**From:** Tomas A. Sanchez  
**Sent:** Tuesday, March 3, 2026 5:43 PM  
**To:** Juan Tejada  
**Cc:** Jose A. Guzman; Eulogio Vera; Jenny Torres  
**Subject:** Re: VARIANCE CASE NO. 2026-0024

Following up on our conversation, the following are my review comment on VARIANCE CASE NO. 2026-0024,

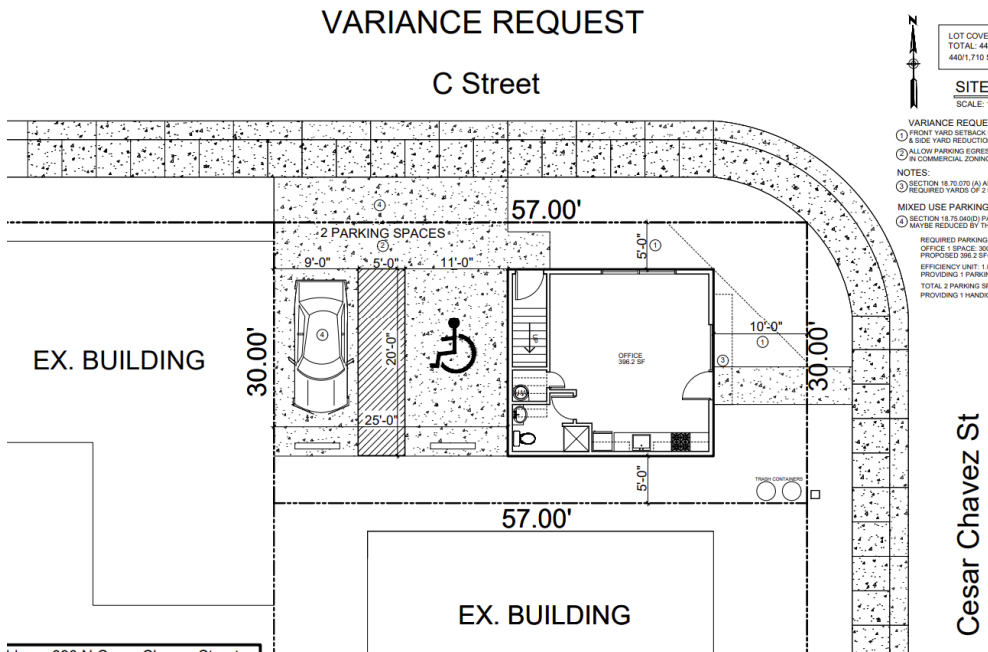
Vehicles would have to back directly onto the street, which is unsafe and does not meet standard parking design practices. The proposed two-space parking layout (screenshot below) creates a safety concern due to the existing residential building to the west and the proximity to the intersection to the east. Mitigation measures or alternative parking designs will be required if the variance is considered.
